## IHLP-6767 Width Tolerance Correction

# Product Information Notification

Product Group: DI/Mon Nov 20, 2023/PIN-DI-00622-2023-REV-0

## Datasheet updates:

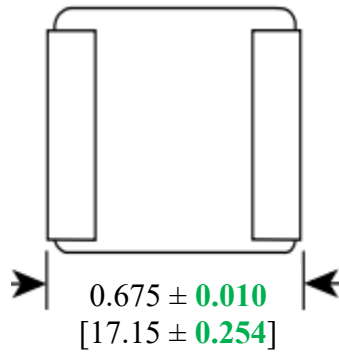
**Description of Change:** The tolerance on the overall part width (terminal-to-terminal) for all IHLP6767\* inductors is being corrected from  $\pm 0.005"$  to  $\pm 0.010"$  to resemble the tolerance listed on most other IHLP products. There are no changes to the part or the manufacturing process. Please see image on following page for more information.

**Reason for Change:** Datasheet being corrected to reflect observed manufacturing tolerances.
